MANDATORY SERVICE BULLETIN

NO. MSB-40-044/1

Installation of muffler brace.

WI-MSB-40-044

Zeichnungs Nr.: **D41-7806-00-00_1** Blatt 1/1 Bl

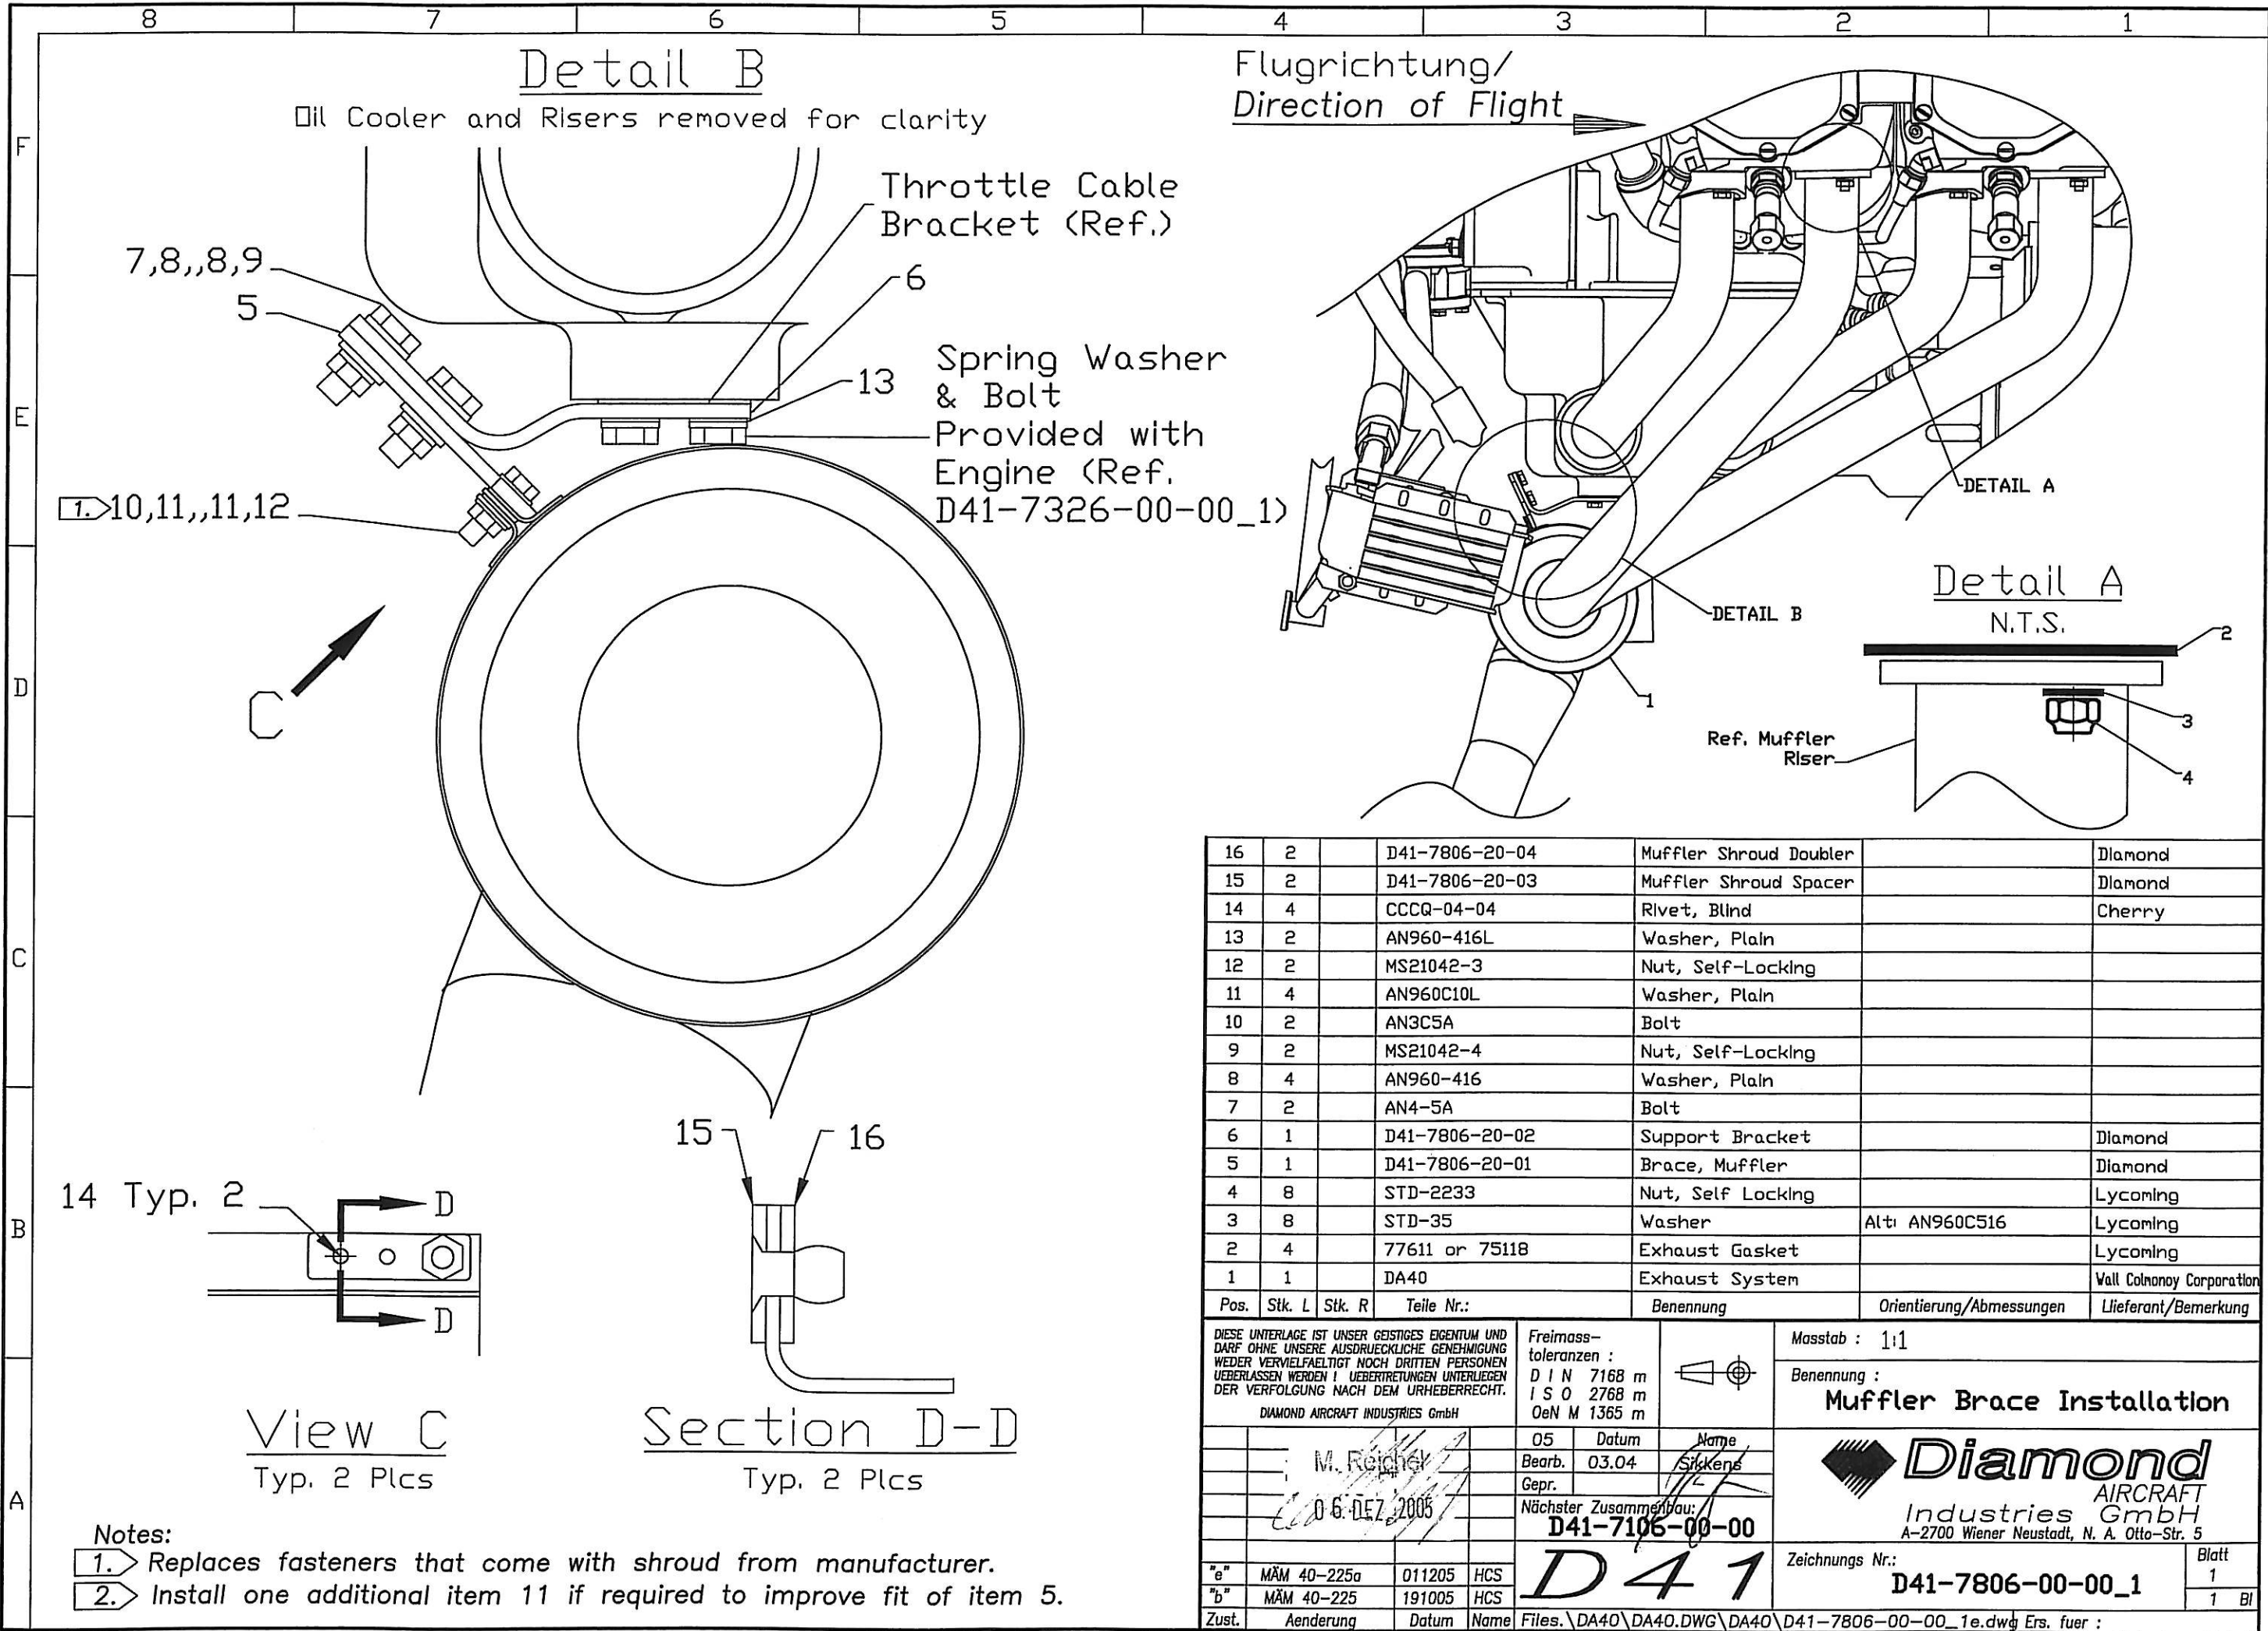
To prevent cracks in exhaust riser pipes.

1	Remove the engine cowlings (refer to AMM Section 71-10).
2	Remove the exhaust muffler from the engine by removing the nuts that fasten the risers to the cylinders (refer to AMM Section 78-00). Discard all used gaskets and star washers.
3	Remove the muffler shroud (refer to AMM Section 78-00).
4	Perform a thorough visual inspection of the exhaust system.
5	Align muffler shroud doubler with outer holes on aft flange of shroud and drill two rivet holes Ø0.125" (3.2mm) at each end of flange.
6	Install muffler shroud doubler and muffler shroud spacer with CCCQ-04-04 rivets as shown in drawing D41-7806-00-00_1.
7	Install muffler shroud (refer to AMM Section 78-00) leaving out outer screws and Tinnerman nuts.
8	Install muffler brace (P/N D41-7806-20-01) onto the upper/forward face of the muffler shroud flange using two AN3C5A bolts, six AN960C10L washers (one under the head of each bolt, one under each nut, and one between the shroud flanges at each location) and two MS21042-3 self-locking nuts.

9	Remove the 2 bolts and washers that fasten the throttle cable bracket to the throttle cable boss. Discard the spring washers but retain the bolts and plain washers.
10	Install the muffler brace support bracket (P/N D41-7806-20-02) to the throttle cable boss using the bolts and plain washers removed in the previous step and new spring washers MS35338-44. Do not fully tighten the bolts. The brace support bracket should be able to move freely. The throttle cable bracket should be in between the brace support bracket and the throttle cable boss.
11	Raise the system up to the cylinders and using new gaskets installed per Lycoming Service Instruction No. 1204B, with plain washers and STD-2233 nuts draw the risers up to the cylinders so they are snug. Tighten nuts sequentially working from one side of the engine to the other in a crossing pattern. Torque to 17 foot pounds (23 Nm) in a minimum of two steps, working sequentially from one side of the engine to the other in a crossing pattern. NOTE: Add friction torque to this value to get final torque.

12	Adjust the support bracket to the position where it is best aligned with the brace. It may be necessary to loosen and rotate the muffler shroud to obtain the best fit between the brace and support bracket. If necessary to prevent the brace from bending, install an additional AN960C10L washer between the brace and the muffler shroud flange.
13	Fasten the brace and support bracket using two AN4-5A bolts, four AN960-416 washers and two MS21042-4 self-locking nuts.
14	Tighten the two throttle cable boss bolts and secure with safety wire.
15	Install cowlings (Refer to AMM Section 71-10).

- Notes:
- 1. Replaces fasteners that come with shroud from manufacturer.
 - 2. Install one additional item 11 if required to improve fit of item 5.
